ADDENDUM NO. 2
WEBSTER DRAIN
SAGINAW COUNTY, MICHIGAN

TO: ALL PROSPECTIVE BIDDERS ON THE SUBJECT PROJECT
RE: CHANGES TO BIDDING DOCUMENTS

3. Enclosed please find the following revised plan sheets:
 - DR-3179-09
4. The following clarifications are being made in response to questions received from bidders:

INLET STRUCTURE DETAIL WITH BAR GRATE
NOT TO SCALE

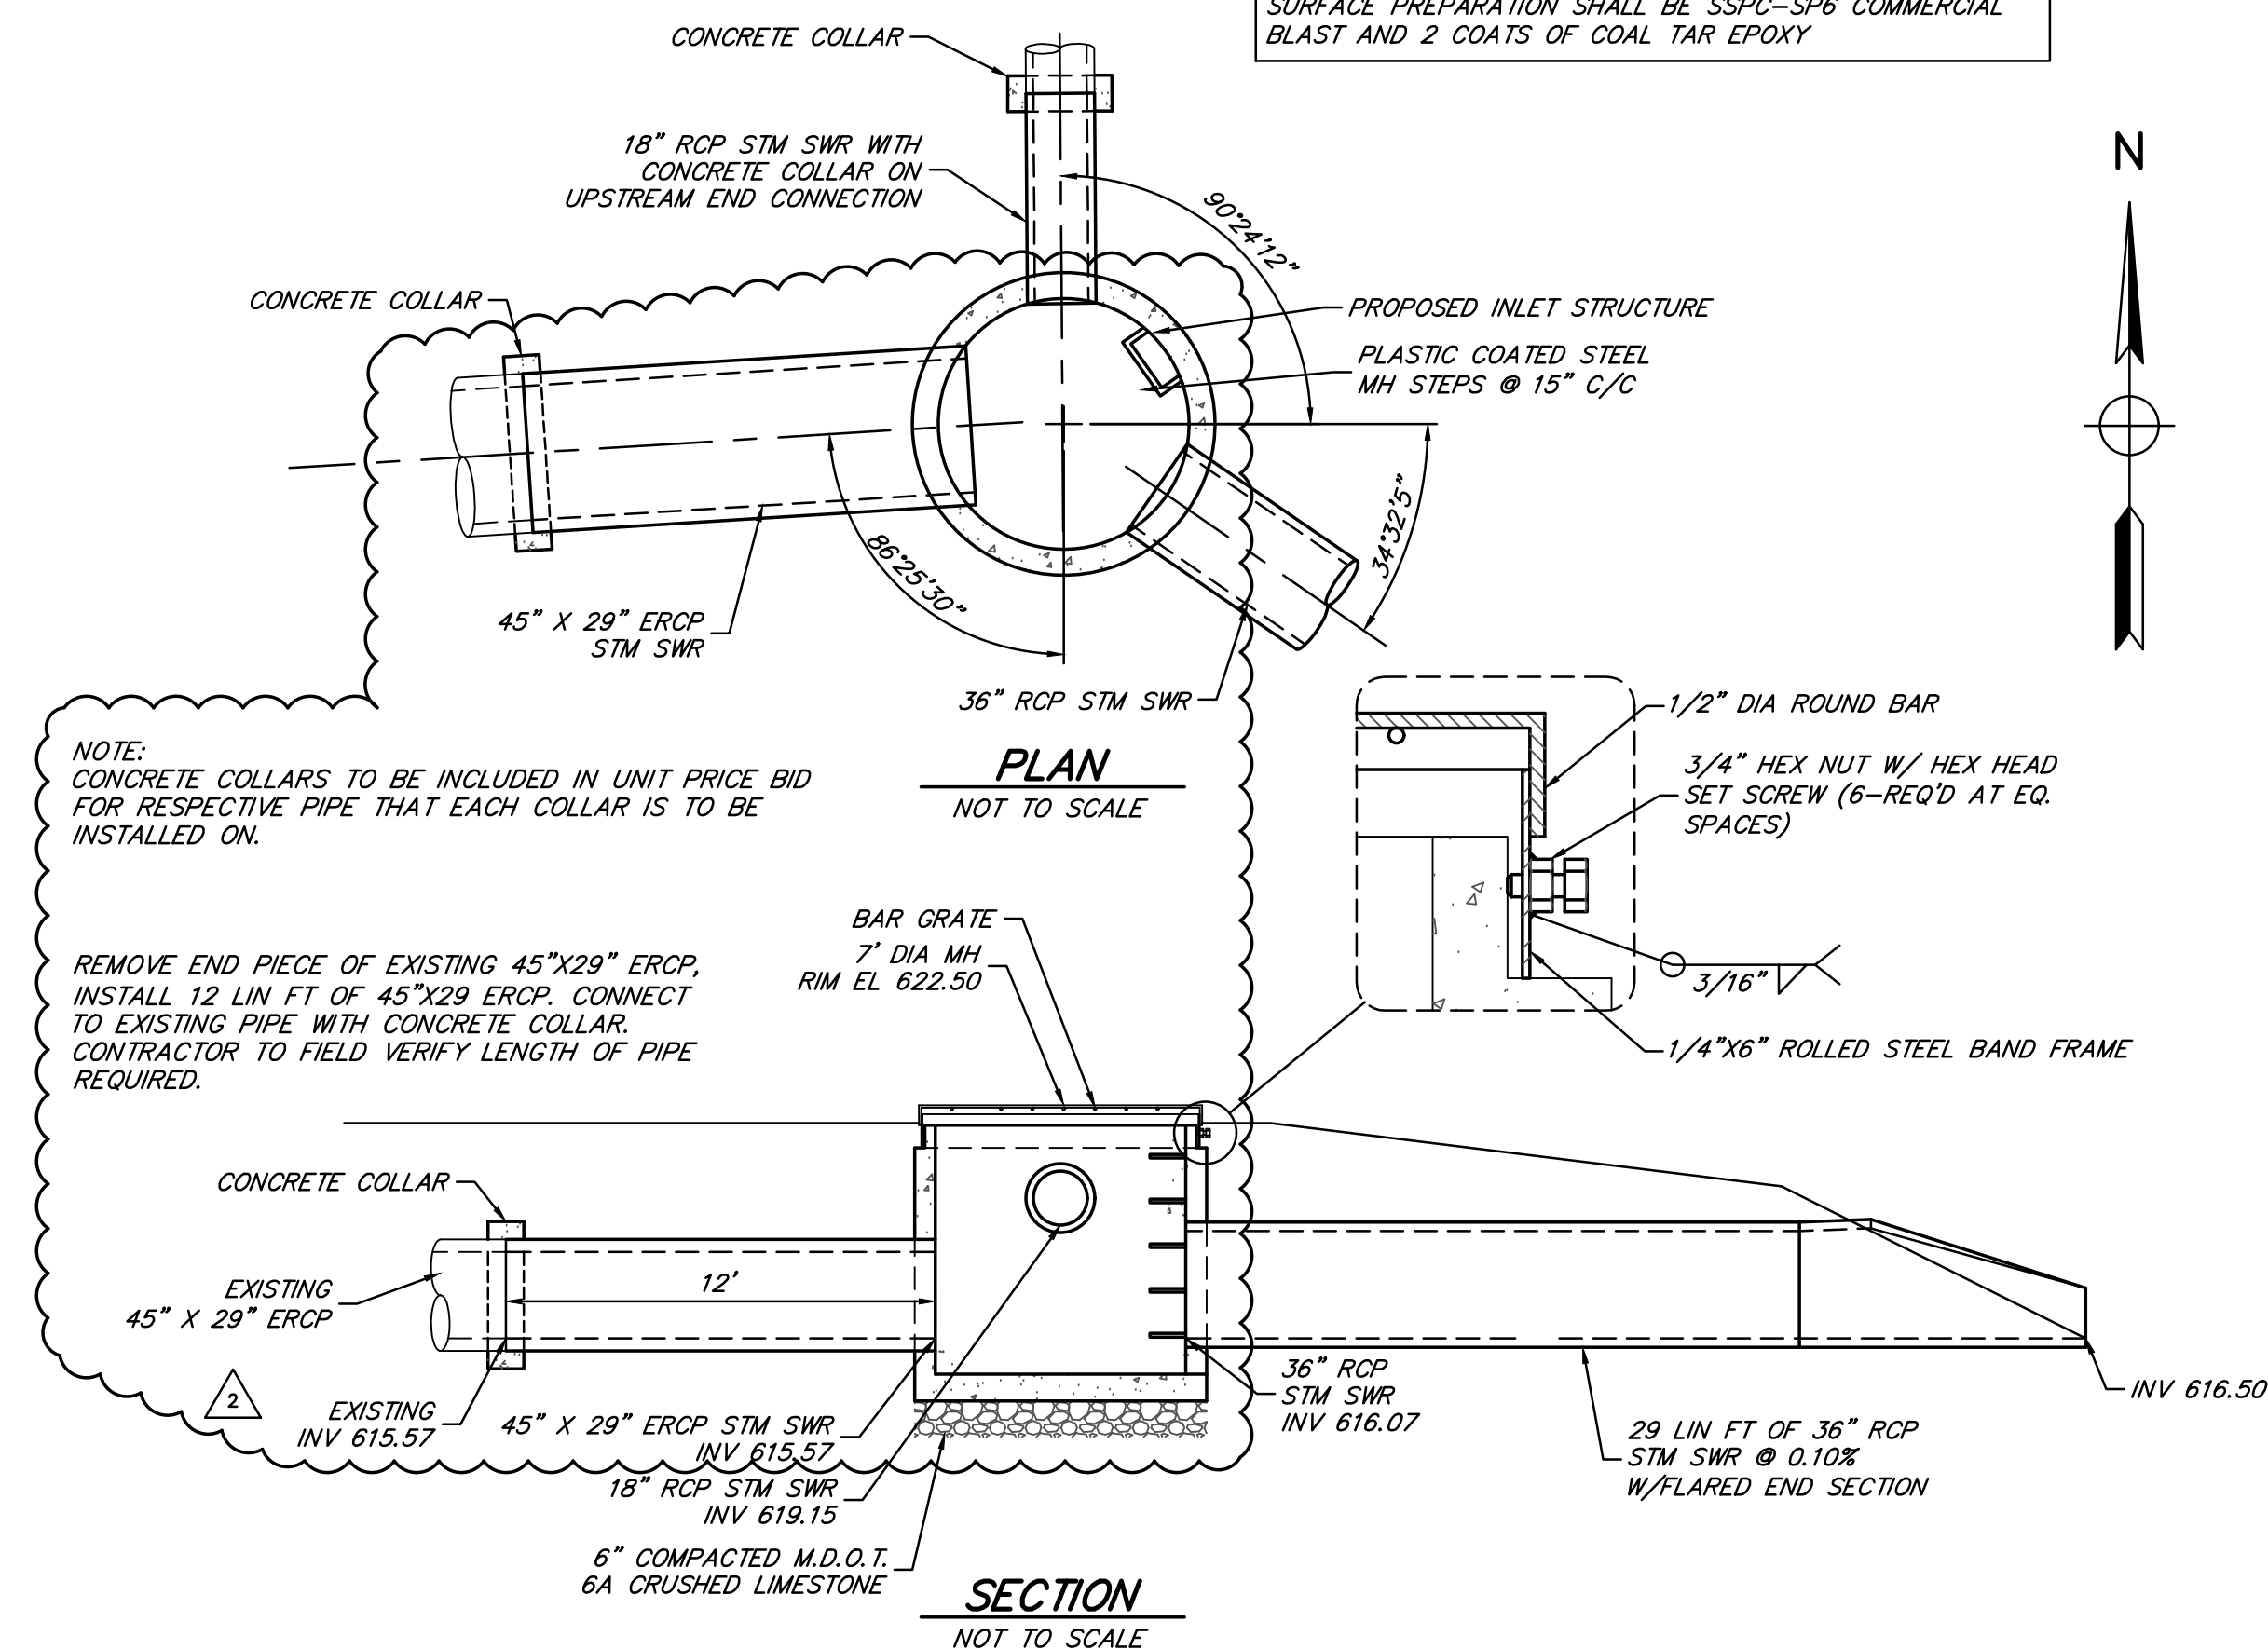
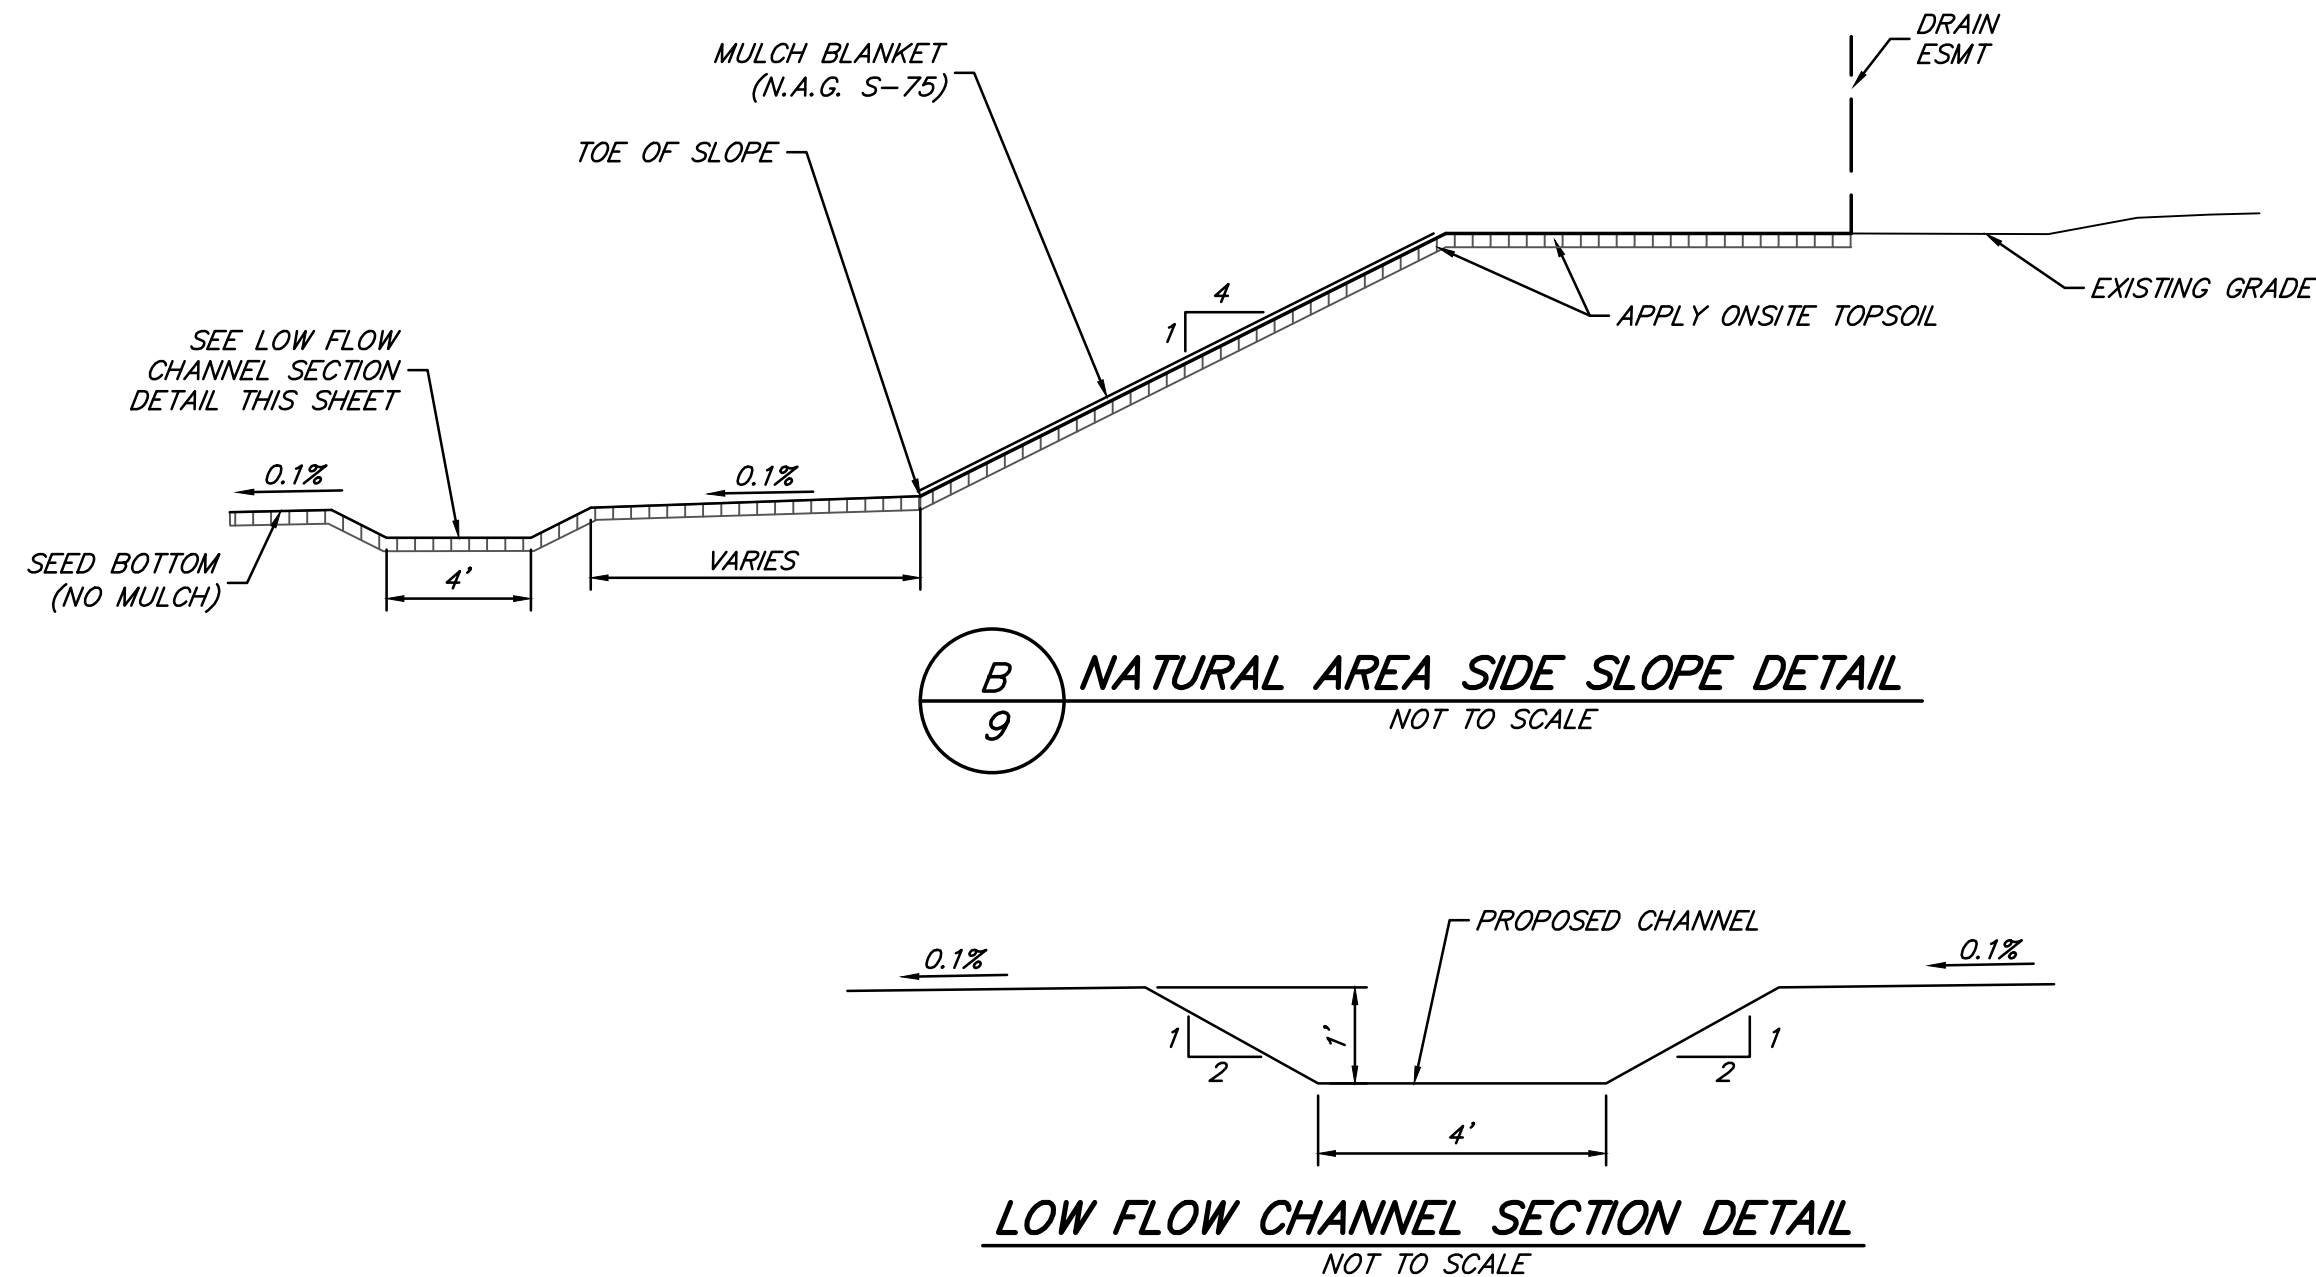
1. Addendum No. 2 has been emailed or made available to you through the Saginaw County Public Works website on Wednesday, October 21st, 2020.
2. Enclosed please find a copy of the revised Bid Form that includes a revised manhole size (Bid Item #32) and outlet pipe size (Bid Item #33) at Carter Road. An alternate bid item (#67) was added for an RCP prefabricated bend to be installed in lieu of the 10' diameter manhole (Bid Item #14) at Structure WD01. **All bids must be submitted using this form.**
